**QUALITY ASSURANCE -- NON-CONFORMANCE REPORT**

**Location:** Changxing Island, Shanghai, PRC **Report No:** NCR-000706  
**Prime Contractor:** American Bridge/Fluor Enterprises, a JV **Date:** 06-Apr-2010  
**Submitting Contractor:** Zhenhua Port Machinery Company, Ltd (ZPMC), Changxing Island **NCR #:** ZPMC-0673

**Job Name:** SAS Superstructure  
**Document No:** 05.03.06-000664

**Reference Description:** CWR - Weld Repair Performed Without Engineer's Approval / North Tower Lift 4, DE Corner Seam / 4th time repair

WELD NUMBER: NSTL4-3B/L-2A/B

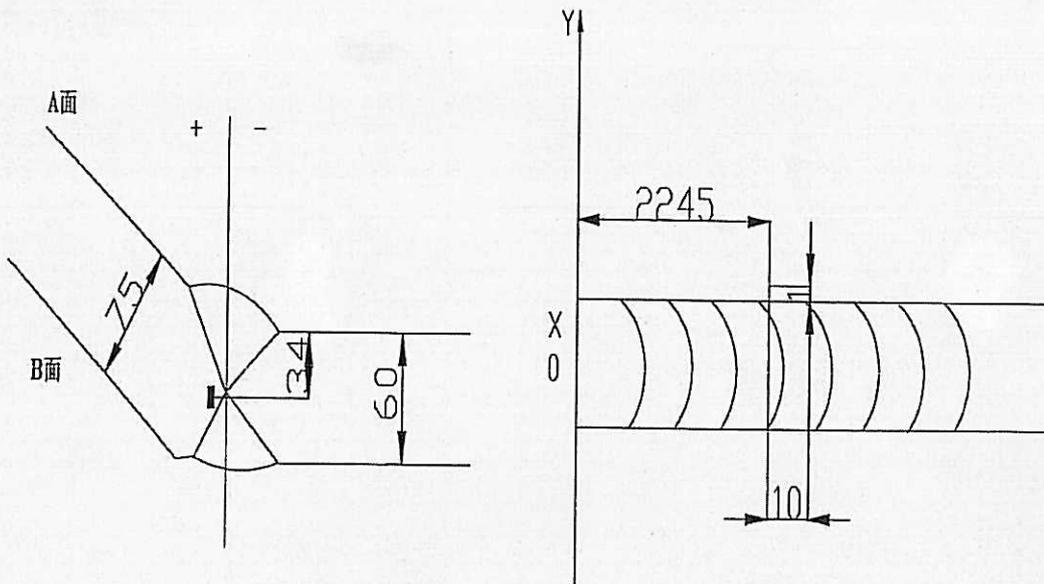
Rejectable indications were found by ultrasonic inspection for a fifth repair (UT探伤返修第5次) NSTL4-3B/L-2A/B

1. 焊缝的位置比较狭窄, 碳刨时, 不能准确的将缺陷刨出.
  2. 打磨工在打磨时, 不够仔细, 没有将所有的缺陷去除.
1. The access space was quite narrow resulting in making it difficult to arc-gouge the defects effectively.
  2. The grinder was not observant during the grinding operation resulting in the indications not being completely removed.

1. QC /CWI shall monitor and direct all gouging, grinding and welding during the repair procedure.
  2. Remove defects by gouging and /or grinding. If gouging is used, preheat the repair area to a minimum temperature of 65°C.

3. Prepare excavation according to the approved repair WPS.
  4. Grind the repair area to a smooth and shiny surface.
  5. Verify that no defects are present by VT and MT prior to welding.

6. Clean excavation of all loose debris and MT powder.
  7. Weld according to the approved WPS.
  8. Preheat and maintain interpass temperature control in accordance to the approved WPS.

9. QC shall ensure all slag has been removed prior to the deposition of the next pass.
  10. Blend the weld repaired areas into the adjacent weld or base metal by grinding.
